EPBC 2021/9085 Havieron Project (WA) – Variation request

EPBC 2021/9085 Havieron Project (WA) – VARIATION REQUEST

Figure 1 Proposed Development Envelope and Indicative Footprint

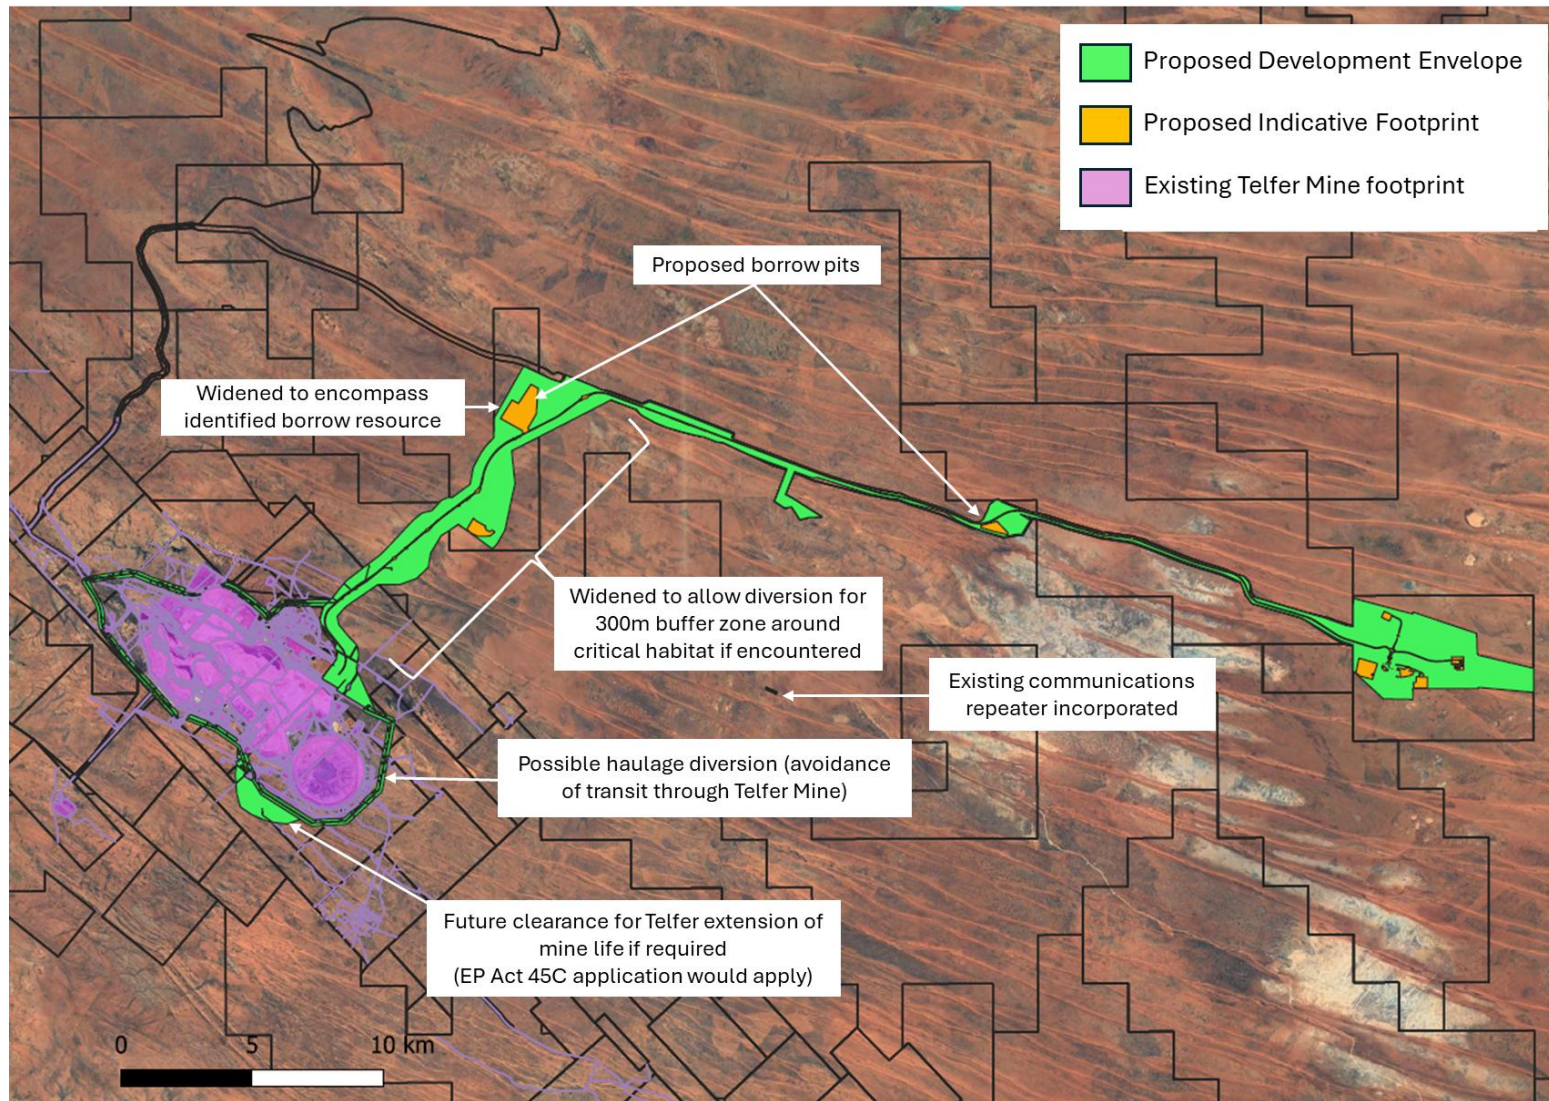
The proposed Indicative Footprint of up to 630 ha of land clearance within the Development Envelope remains unchanged. However, since acquisition of the Telfer – Havieron project in December 2024, Greatland have reviewed surface infrastructure alignments and resources. We seek to take this opportunity to provide updated spatial data for the Indicative Footprint to reflect the following:

- Revised haul road alignment
- Borrow pits
- Further opportunities taken to re-use existing clearances

Of the 630 ha approximately approximately 472Ha is currently shown in the indicative clearance footprint, with an additional 50Ha expected once detailed design has confirmed infrastructure locations within the envelope. The unallocated aspects are:

- Haul road alignment around the Telfer Mine given. This decision will be made at detailed design based on consideration of mine safety and operational factors at Telfer
- Any future amendment to the existing Telfer Mine. This is a highly conceptual future decision (>5 years if required), however it is considered prudent to ensure it is included in the Development Envelope

The proposed Development Envelope and Indicative Footprint are illustrated with noted features in Figure 1.

Figure 3 Extent of fauna habitats within the varied Development Envelope

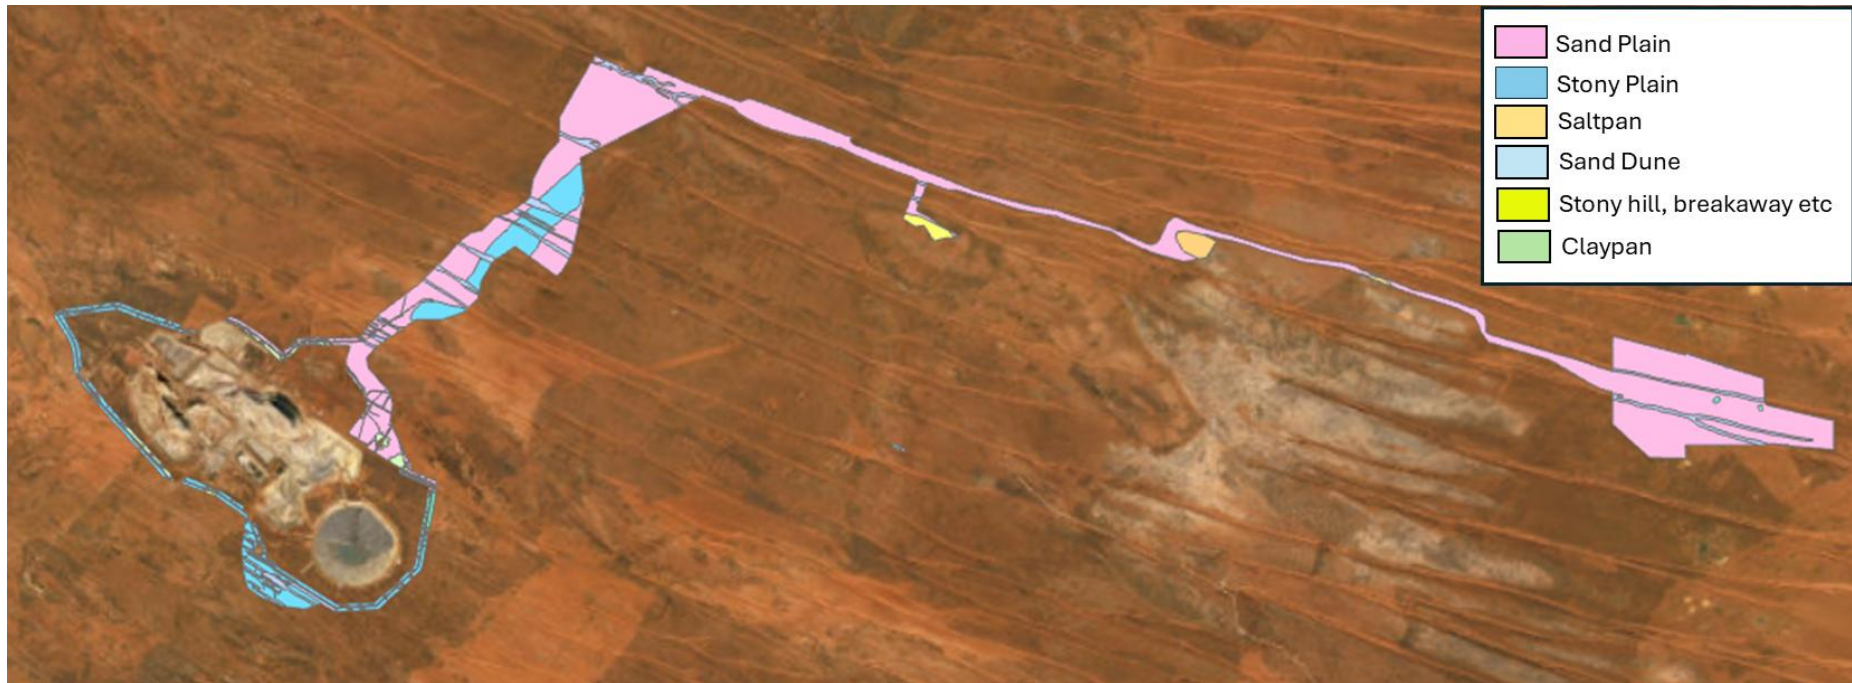
Increase in the Development envelope of 1,804 ha, from the current 3,979 ha to 5,783 ha.

The extent of the six identified habitat types is shown in Figure 2. Their extent within the current and proposed Development Envelope are provided in Table 1 and Figure 3.

Figure 4 Extent of Greater Bilby recorded within and around the current and varied Development Envelope

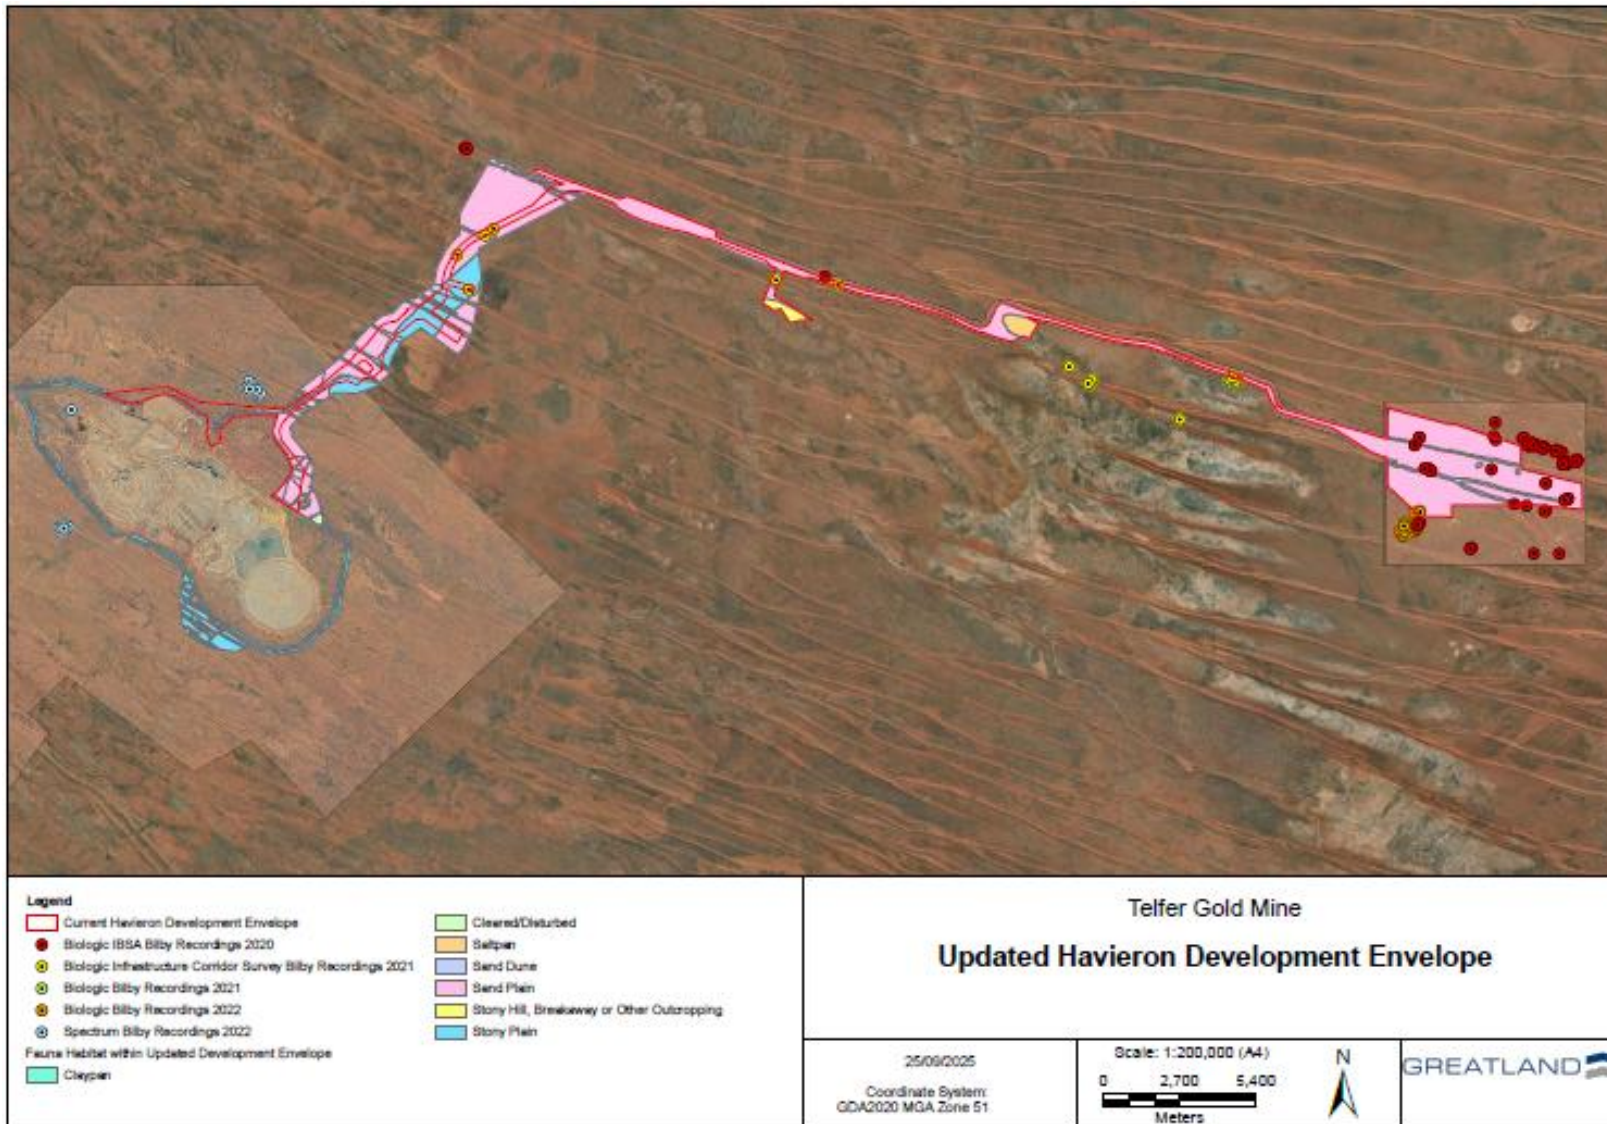
Actual recordings of Greater Bilby in relation to the existing and varied Development Envelope are shown in Figure 4. There is no change to the extent of recordings between the current and proposed Development Envelope.
